**URGENT – FIELD SAFETY NOTICE**

**GETINGE ED-FLOW AER, ED-FLOW SD AER  
SOFTWARE UPDATE – Field Action 2016-01**

**Field Action 2016-01 / CAPA 167835**

*Duration of reprocessing cycle and product intake in an ED-FLOW or ED-FLOW SD AER*

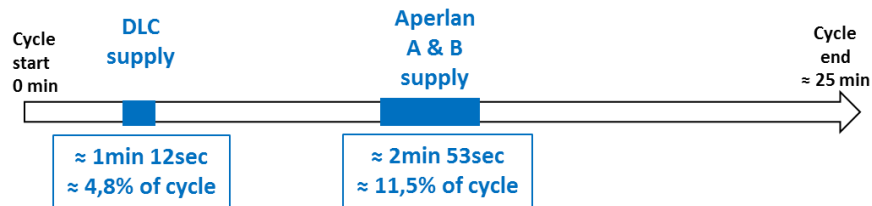
The issue we found can cause a lack of product supply (DLC detergent or Aperlan Poka-Yoke Agent A and Agent B disinfectant) if the compressed air supply of the machine is lost right before or during product supply, and after cycle start, and not re-established before cycle end (periods in blue on timeline).

This issue was raised during final testing of an ED-FLOW during the manufacturing process at the factory and we have not received any complaint related to this issue. **From our investigation, it was concluded that the probability of failure occurring is limited to a compressed air supply loss right before or during the product supply phases of the machine (about 4 minutes and 5 seconds).**

This potential for malfunction is caused by a design error in the software source code: the product supply function is wrongly conditioned by air presence. We have developed a new version of the software and removed this wrong condition in the source code. **In version 3.1.0, the product supply function is no longer conditioned by air presence.** The devices involved for your market are all Getinge ED-FLOW AER or ED-FLOW SD AER.

1. Please make sure that all caregivers and users of the Getinge ED-FLOW AER or ED-FLOW SD AER referenced on the previous page are made aware of this Field Notice and all listed devices at your facility are available to be updated during the Getinge service technician visit.
2. Complete and sign the enclosed Customer Response Form and return this form to the local Getinge office.  
**Note:** A Getinge Sales or Service person will contact the person you listed on the Customer Response Form to schedule service to **update your device to version 3.1.0 of the software**, free of charge.
